Director | Carriageway Consulting Limited

Simplify the Site Plan

Level of Car Park (Option 3)

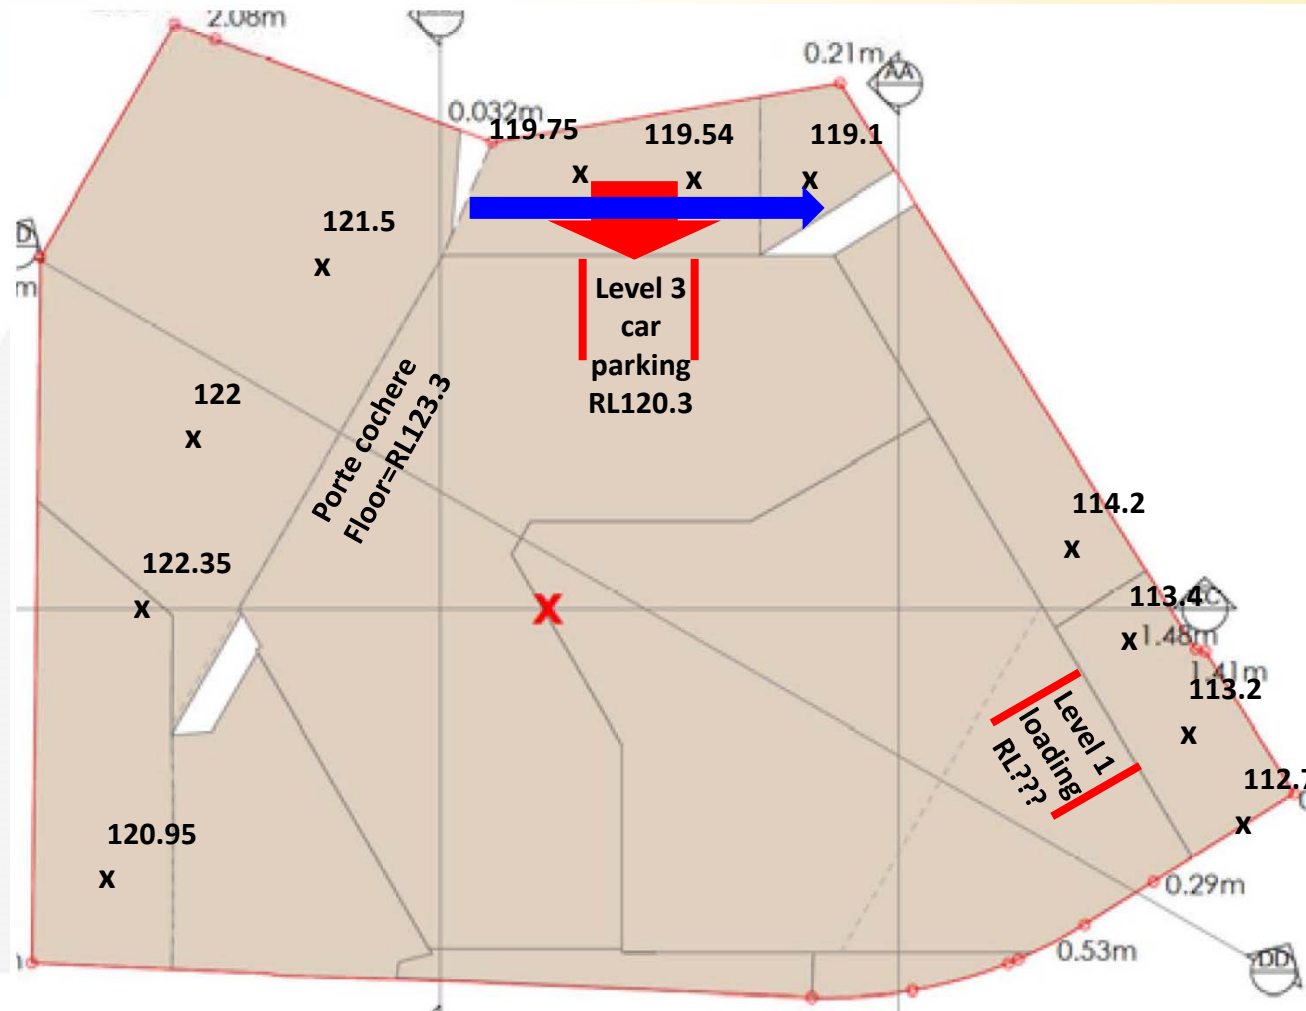
If levels were retained then a ramp could be created up to the car parking level

Ramp gradient would be 1 in 6.5 and usable by cars

But would mean a 1 in 6.5 crossfall for coaches and service vehicles

Coaches and service vehicles could not traverse this

Internal Ramp in Car Park

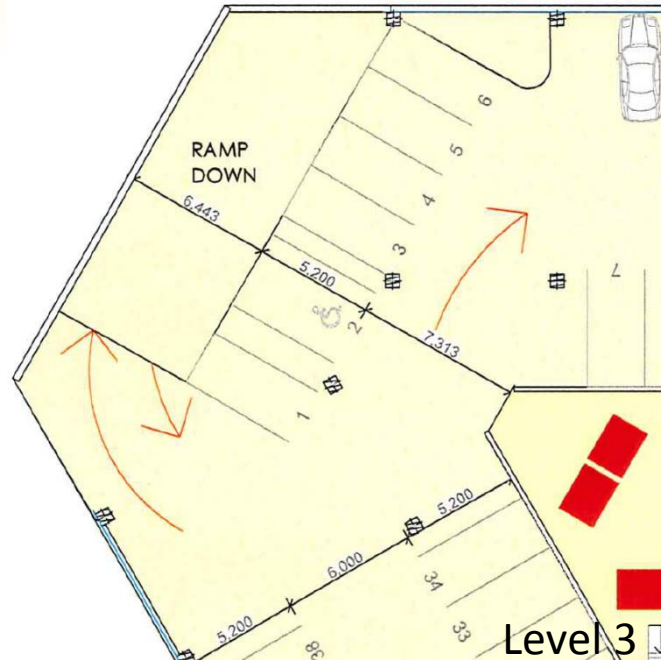
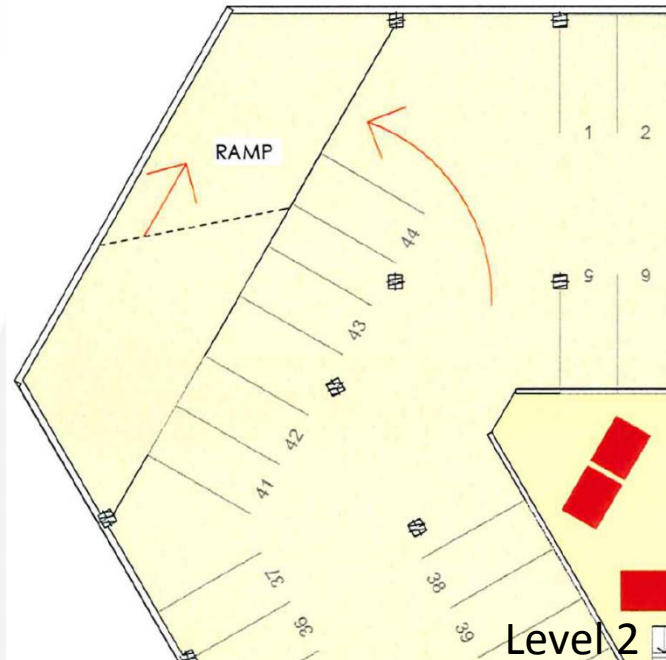
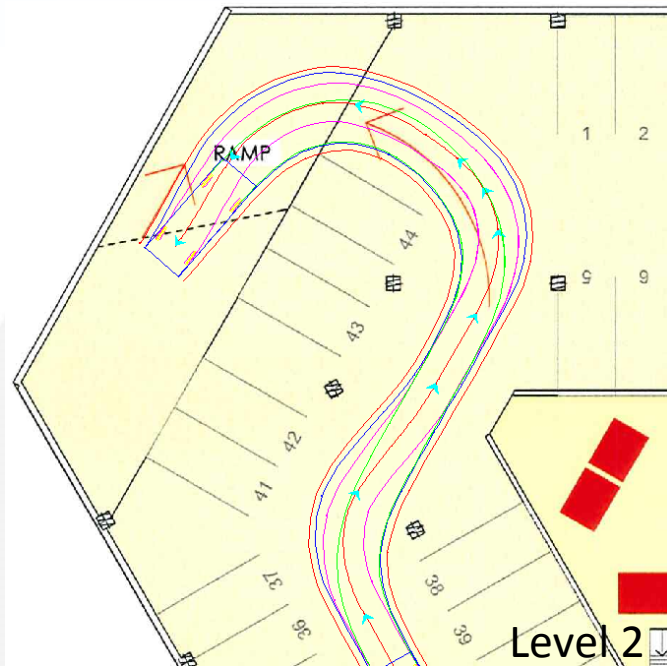
Length of ramp is 11.5m

Required change in height between floors is 3.0m

Therefore gradient is 1 in 3.8

So transition ramps needed or cars will scrape bodywork or get jammed

Ramp must therefore be:

- 2m at 1 in 6.7 (transition)
- 7.5m at 1 in 3
- 2m at 1 in 8 (transition)

Problem: Main part of ramp at 1 in 3 is much greater than Standards permit

'Best Case' Swept Paths of Vehicles on Ramp

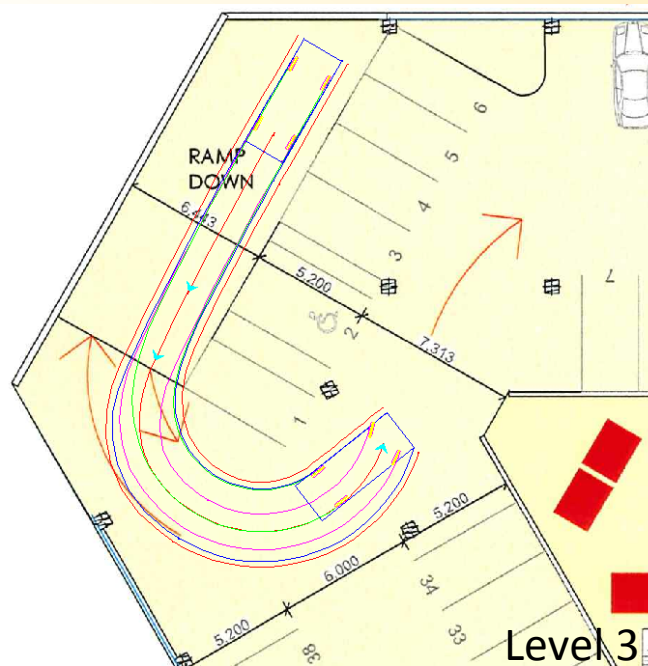
Blue line: vehicle bodywork
Red line: 0.3m clearance to vehicle bodywork

Car travelling up ramp on minimum radius occupies the full ramp width

Even if it could move to the side, it requires the full width to turn at the top

Therefore ramp and approaches can only operate as a single traffic lane

No robust controls proposed on ramp, so high potential for one car to encounter another

Valets would need to reverse on the ramp and around a blind corner

Other Issues (1)

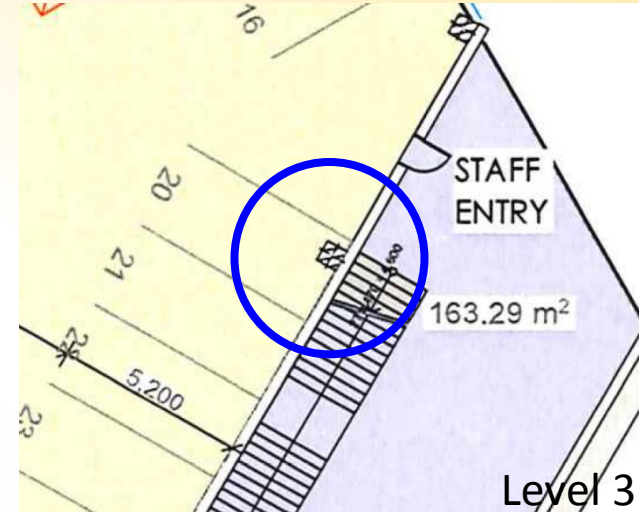
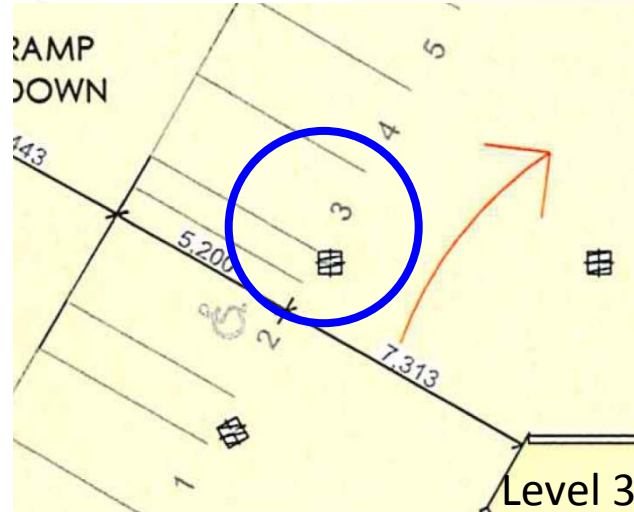
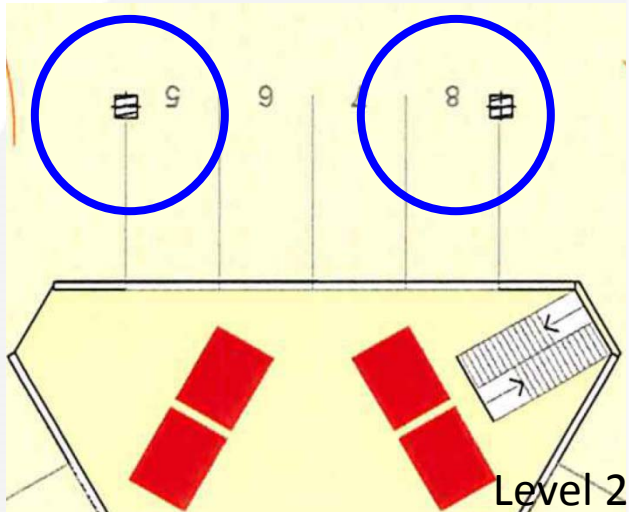
Coach Strikes Building?

Unusable car parking spaces shown on plans (7 in total)
